WRITTEN STATEMENT

**BY SAM BLAKESLEE, PH.D.
CALIFORNIA STATE SENATOR, FORMER
CALIFORNIA SEISMIC SAFETY COMMISSIONER, FORMER**

**TO THE
SENATE COMMITTEE ON ENVIRONMENT AND PUBLIC WORKS**

DECEMBER 3, 2014

Figure 10. Comparison of Individual 84th Percentile Ground Motion Prediction Equations with Best Estimate Parameters and Diablo Canyon Review Spectrum

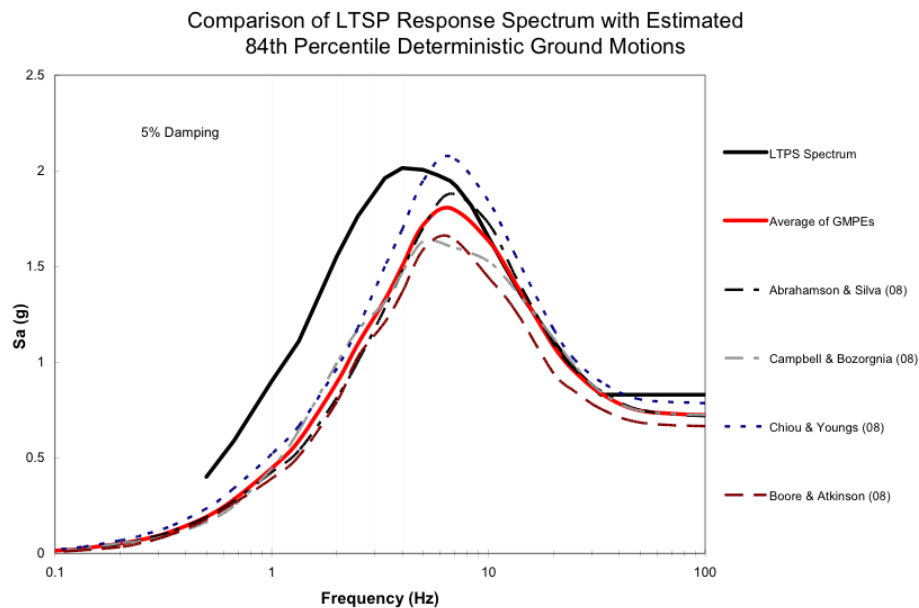
The five NGA GMPEs which, when averaged, produce GMPE-3 are each shown in figure 10 from the NRC report. The NRC staff analysis also tested the significance of using the lower-bound estimate of rock velocity rather than the “best estimate” (lower velocity corresponds to higher shaking). Using a rock velocity of 800 m/s instead of 1,100 m/s resulted in a spectrum that, “exceeds the LTSP spectrum by a small amount over some frequencies.” In summary, by using reasonable but somewhat more conservative approaches to the three available variables (the NGA model selection, earthquake magnitude estimate, or rock

velocity) the spectrum was found to be “very close” or “exceeds...by a small amount.” This result was quite significant because it showed that, even in the early days when the Shoreline Fault was still believed to be relatively small, shaking could exceed the LTSP Spectrum assuming certain models and certain rock parameters. The Chiou & Youngs (08) GMPE (dotted blue line) exceeds the LTSP Spectrum (solid black line) at about 7 Hz and above, the others are just a little below, hence the characterization that they are “*very close*” (emphasis added).

This result naturally raises important questions about the effect of the new GMPE applied to the Shoreline. For example: would estimation of shaking on a 24 km rupture of the Shoreline Fault have exceeded the LTSP if GMPE-1 was used rather than GMPE-3? Given what is shown in Figure 10 it appears that the answer would likely be “yes” if the difference between GMPE-3 vs GMPE-1 was anything other than de minimis, but that analysis was not performed in the 2009 Shoreline report.

Figure 3: Shakal et al., 2004 showing remarkably high and low accelerations in the extreme near-field (rupture started where the star is shown and then propagated to the north-east and south-west where they stopped)

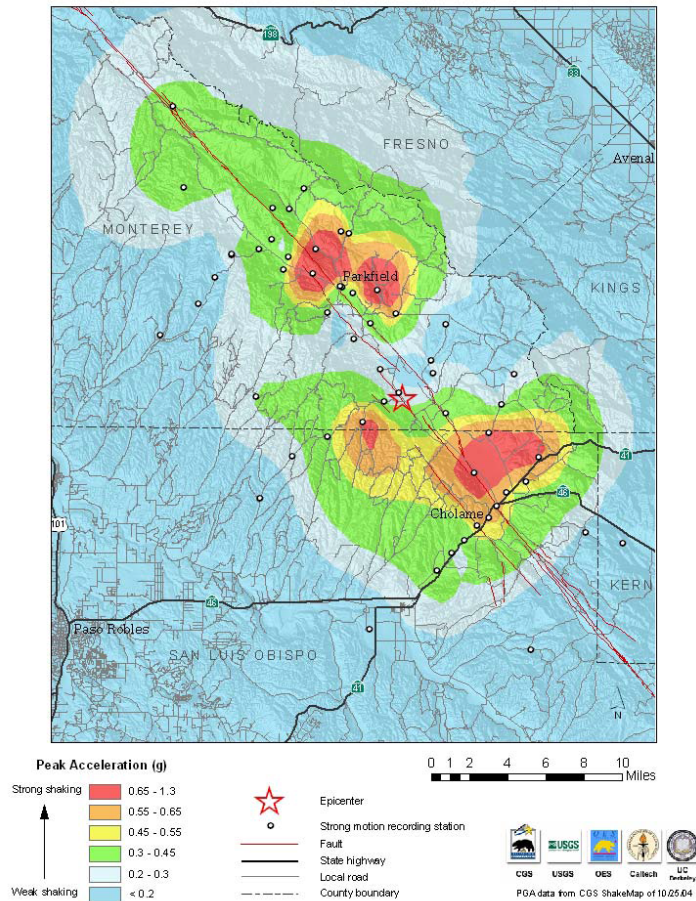
For example, in 2004, 48 strong-motion recordings within 10 km of the San Andreas Fault were made of the M6.0 Parkfield earthquake^{xii}. This dataset was used to test three different attenuation-distance equations. These equations are shown to do a good job of making accurate predictions for distances beyond about 10 km, but the observed shaking becomes highly variable in close proximity to the fault. Rather than finding accurate predictions of mean shaking in the extreme near-field the paper notes,

“Peak ground acceleration in the near-fault region ranges from 0.13 g at Fault Zone 4, to 1.31 g at Fault Zone 14, ten times larger, to over 2.5 g at Fault Zone 16 (where the motion exceeded the instrument capacity and the actual maximum value is still being estimated).”

The dense strong-motion Parkfield recordings are relevant to the conclusions of the Report for a number of reasons.

energy during the rupture process of this specific earthquake. If the nuclear power plant happens to be located in a zone of focused seismic energy the 84th percentile estimate from the GMPE estimate will likely underestimate the observed shaking.

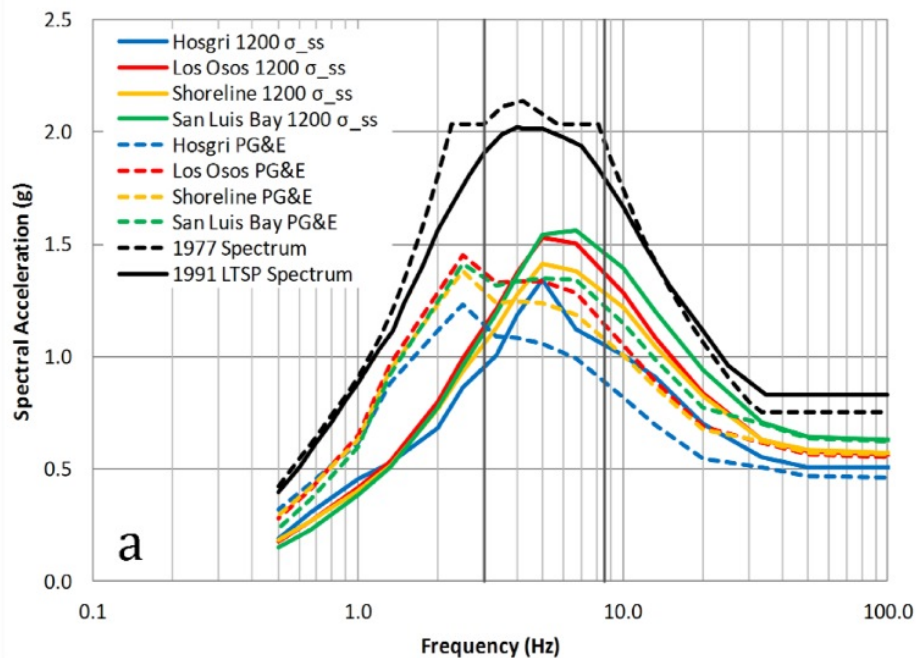
As seen in Figure 7a from the Independent Peer Review Panel (IPRP) report and in a number of other related reports, the new less-conservative equations cause a major reduction in shaking across the entirety of the frequency spectrum from a hypothetical earthquake on the Hosgri fault (compare blue lines which use the newly devised methods with black lines which use the prior methods, in figure 7a above). In the frequency range from 2-10 Hz the less-conservative methodologies have cut the maximum estimated acceleration from 2 g down to about 1.3 g. At the peak-frequency range, from 30-100 hz, the maximum estimated acceleration as been reduced by a third from .75 g to under .50 g. In fact the de-amplification effect is even larger than this comparison suggests because the blue lines, which represent the shaking on the re-interpreted Hosgri, assume a larger rupture on the Hosgri Fault than the earthquake that was used to initially create the 1977 HE basis exception.

More importantly, as can be seen in Figure 7a the shaking from the Los Osos, Shoreline, San Luis Bay Faults all exceed the re-interpreted Hosgri (red, yellow, green lines are all above the blue line). **One can reasonably conclude that, if the original analytical methods had been used to estimate ground motion, the new seismic threats would exceed the original HE and LTSP spectra.**

Figure 7. Continued.

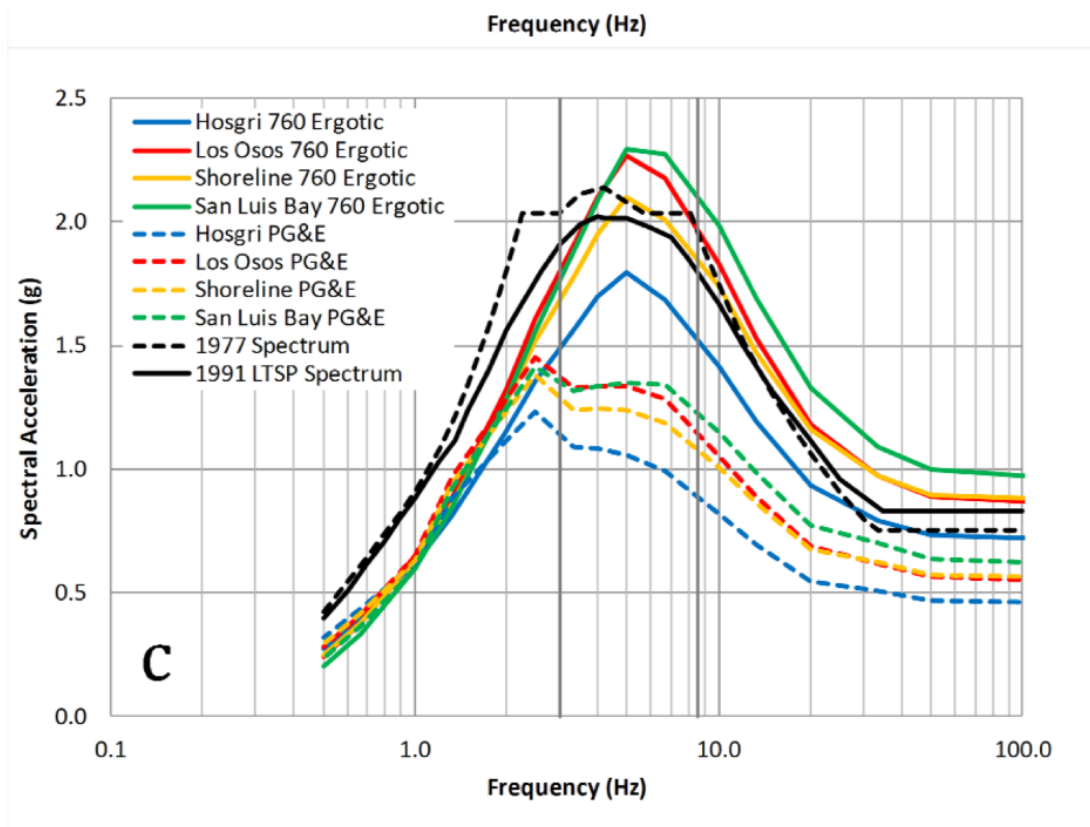
“These two figures also show that if DCPD site had a Vs30 value of 760 m/s rather than 1,200 m/s, and if the site behaves more like an average site in ground motion amplification, **some deterministic spectra would exceed the 1991 LTSP spectrum^{xiii}**” (figure 7c below).

In fact, it is more than just “some.” Under the scenario shown in Figure 7c the IPRP shows that the LTSP/HE spectrum is exceeded by **all** of the newly discovered and re-interpreted seismic threats, including earthquakes on the Shoreline Fault, the Los Osos Fault, and the San Luis Bay Fault (note that the red, yellow, and green lines are all above the solid black line). The fourth and largest hypothetical earthquake scenario, a M7.3 rupture on a joint Hosgri/Shoreline Fault, is not shown on this figure but could reasonably be assumed to exceed the LTSP/HE as well.

This sensitivity analysis shows that the cumulative effect of less-conservative fast rock velocities along with less-conservative GMPEs is clearly not a small issue, nor is it a only an academic issue. The IPRP reviewed the limited wellbore data (see IPRP Report 6 Figure 4) and concluded that the wellbore velocities appeared to be lower than those estimated by PG&E, which could result in the conclusion that PG&E has underestimated shaking from new seismic threats even if the new equations are allowed. The IPRP challenged PG&E's use of wellbore data at the ISFSI site to justify the higher 1,200 m/s velocity and instead focused on the velocities measured in the wellbore data closest to the facility.

Figure 4. Shear wave velocity profiles from 1978 downhole velocity surveys (provided by PG&E).

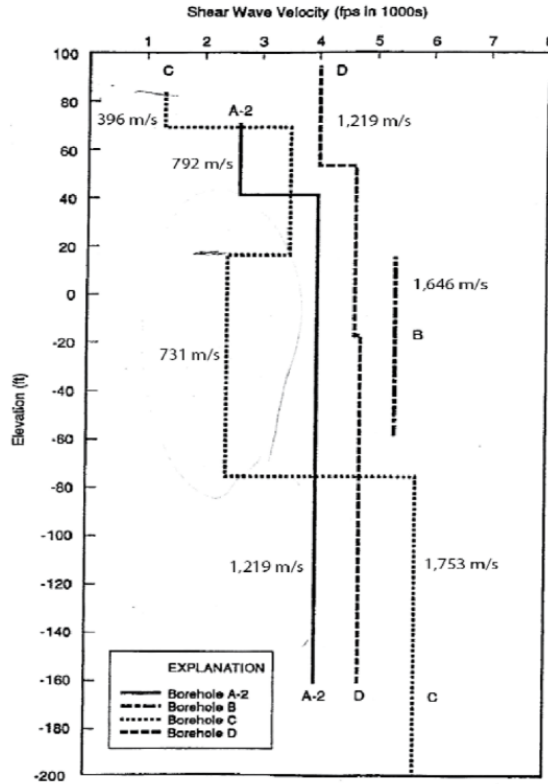
“Consider the three usable measured profiles, A-2, C, and D, the mean value at 10 m is approximately 800m/s, considerably below PG&E's mean of 1200m/s.” and “If A-2 had the same velocity as C at a depth of 5m, consistent with the relative weathering described in the borehole logs, the mean velocity at that depth would be about 650m/s, also below PG&E's mean value of 1000m/s.”

Second, even if one were to accept the use of GMPE-4, which is problematic for the reasons previously stated, the critically important rock velocities upon which the de-amplification factors are based are complex, in dispute, and arguably lower than those used by PG&E, which would mean that shaking would be significantly larger than stated in the Report. Indeed, a conservative approach toward this technical question would have used of the lowest velocities found in the well data rather than the highest.
